**PLAN COMMISSION MEETING
IN PERSON AND VIA ZOOM
TUESDAY, NOVEMBER 4, 2025 – 6:30 PM
CITY HALL – SECOND FLOOR**

SITE PLAN REVIEW REPORT TO THE PLAN COMMISSION

PROPERTY ADDRESS: 1200 Industrial Dr.

FILE NUMBER: SPR-2025-29

SHEET NUMBER
A2.0

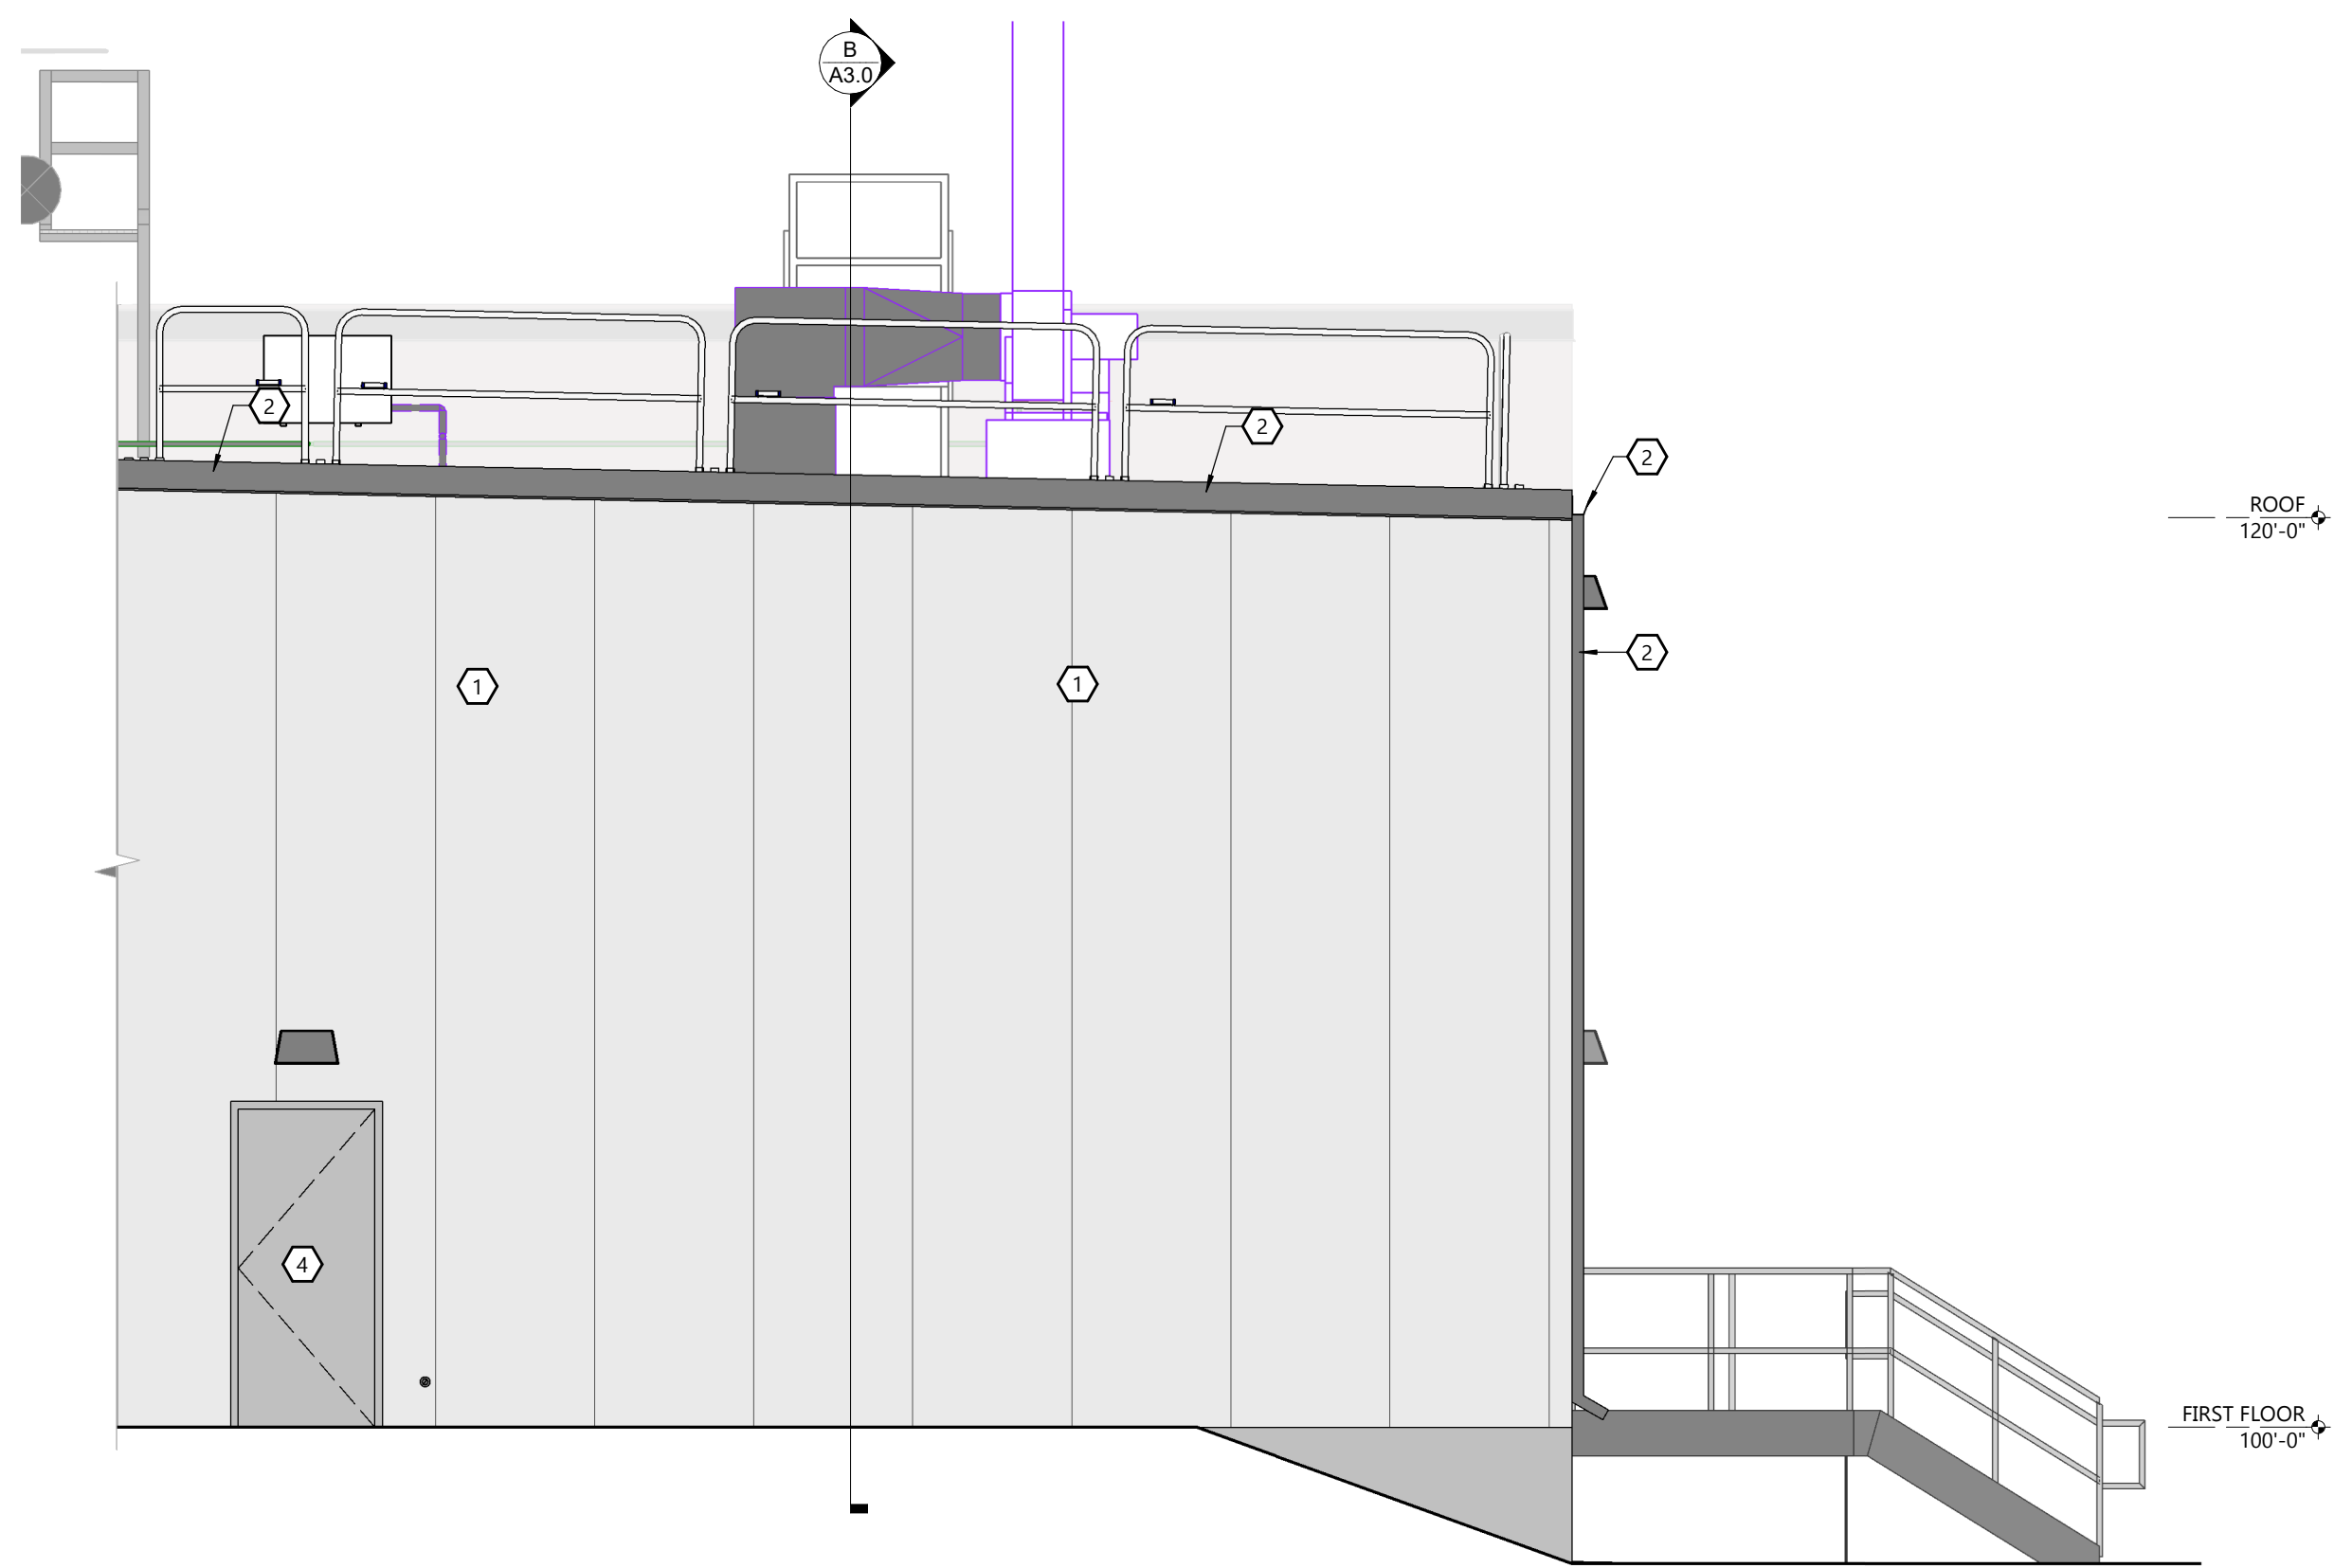
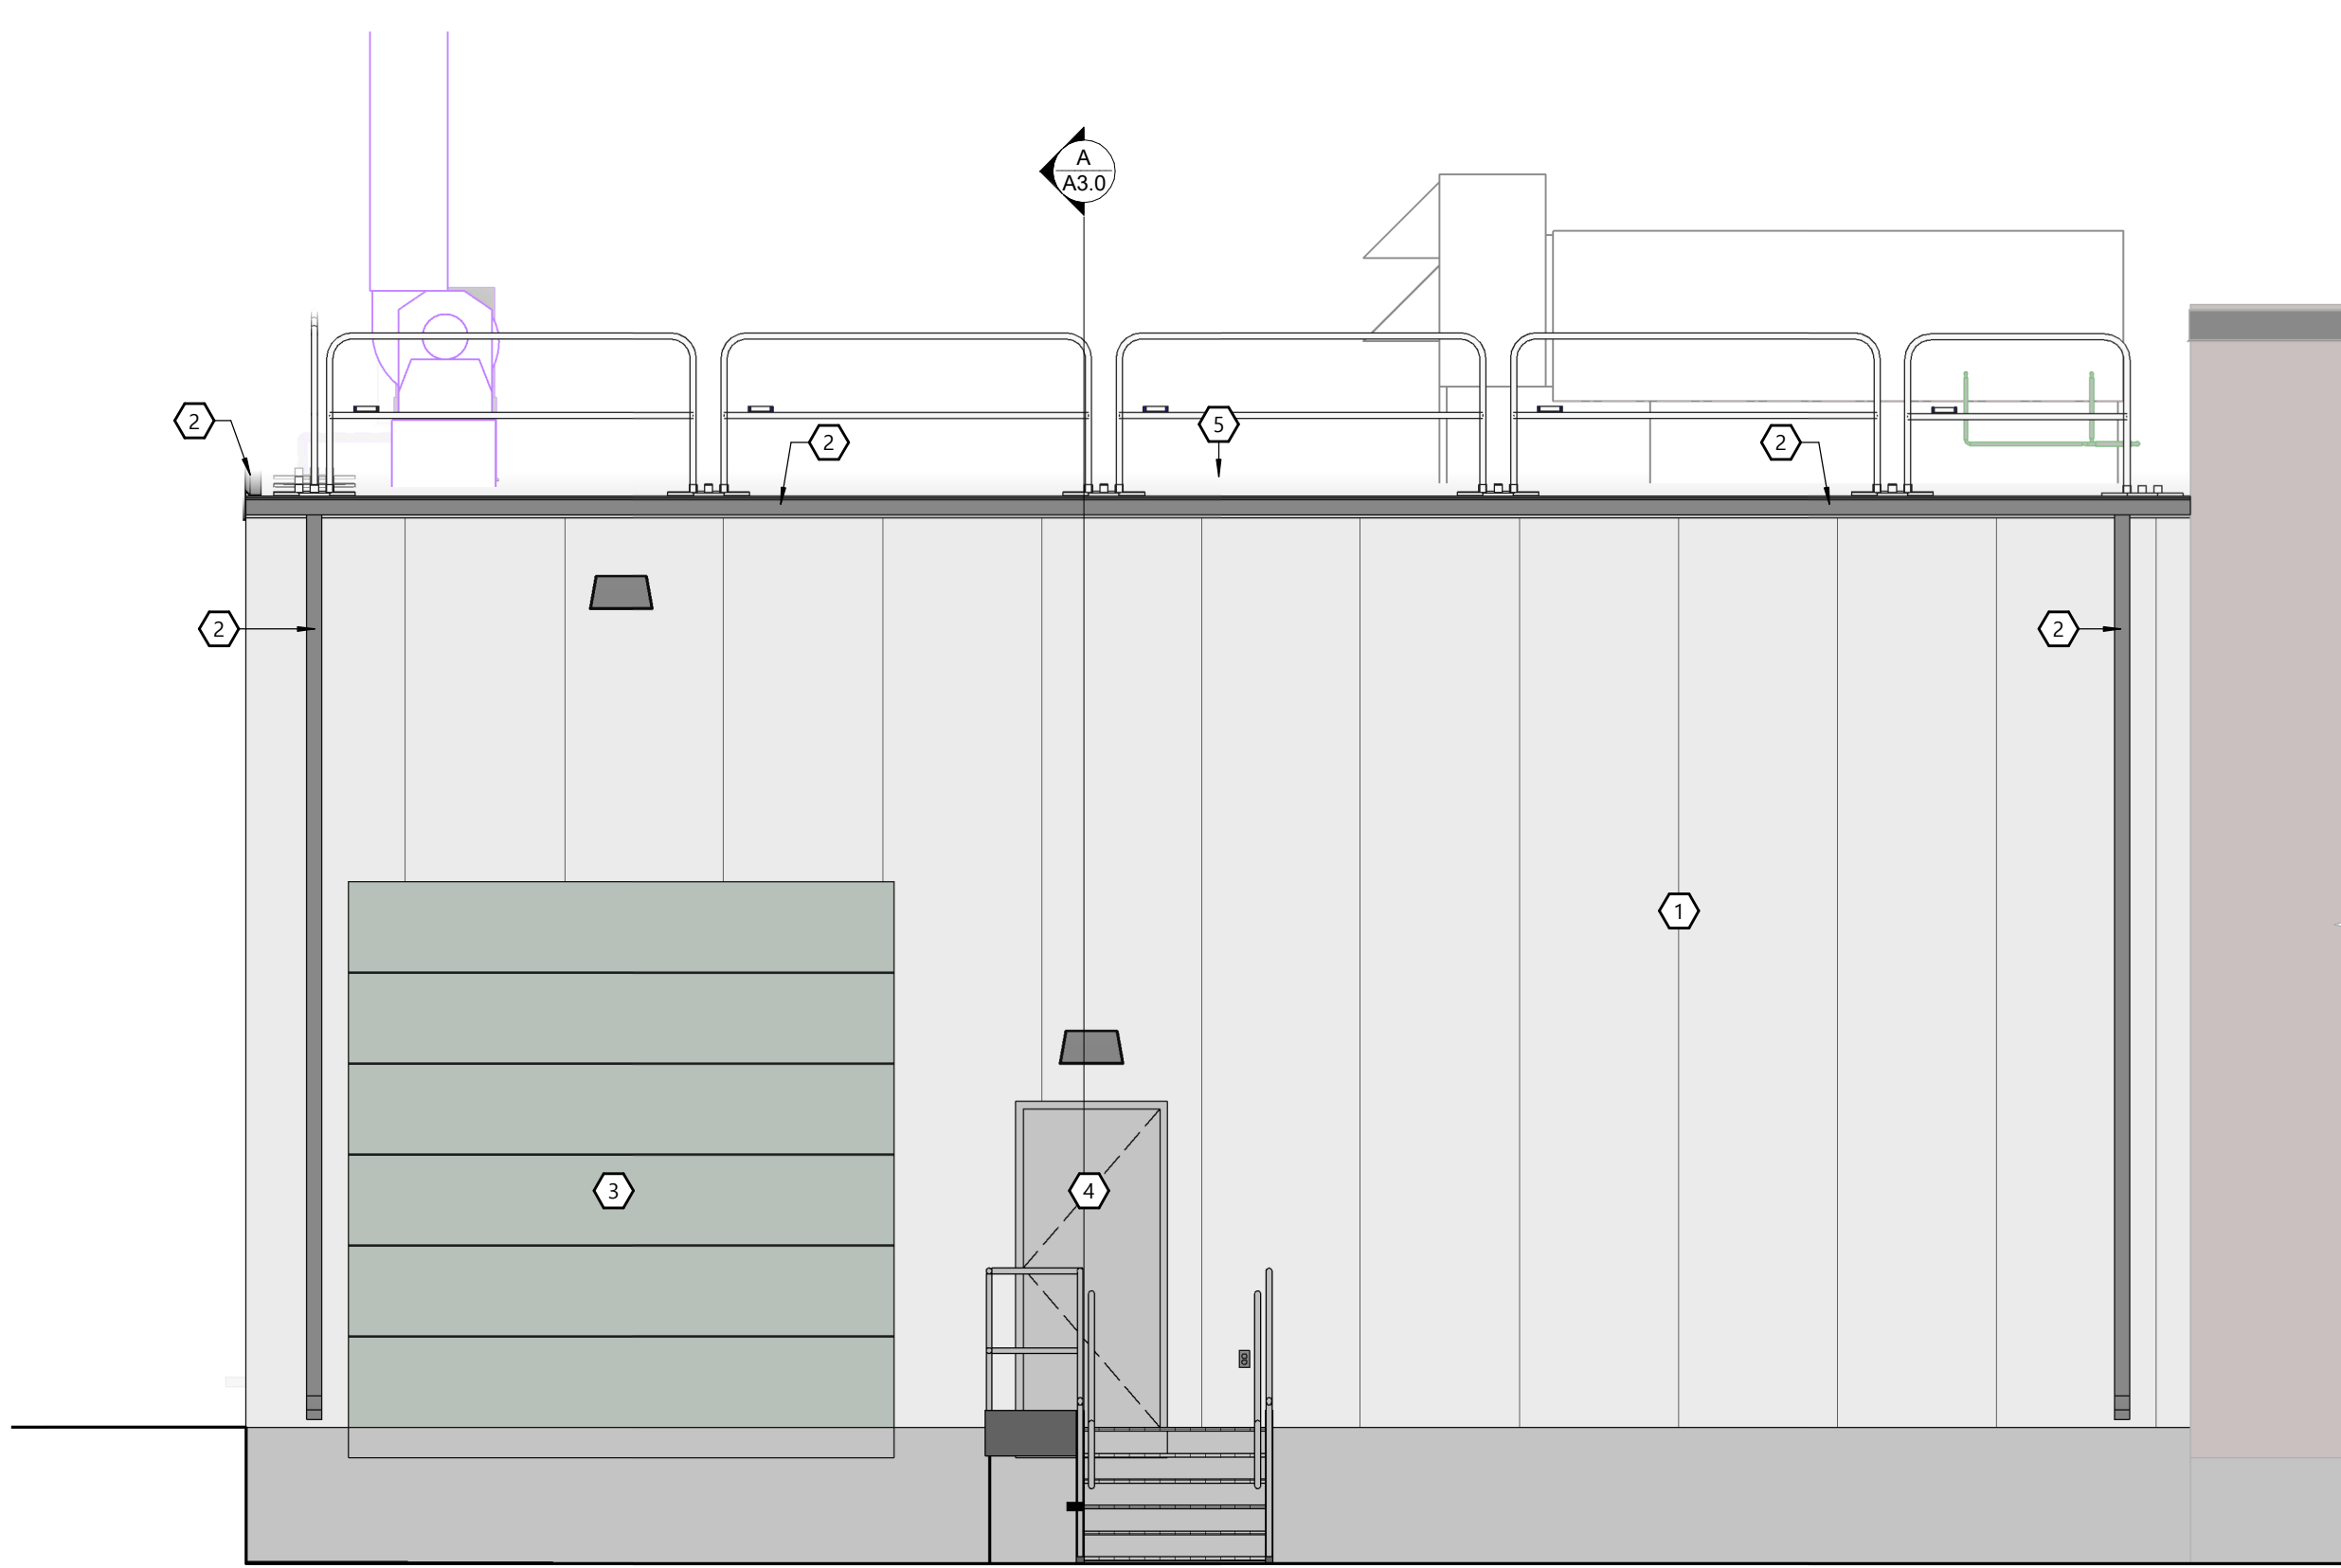
Per Section 15.07.01(2)(b), additions shall match or be substantially similar to the design and materials of the existing building = met (metal wall paneling)
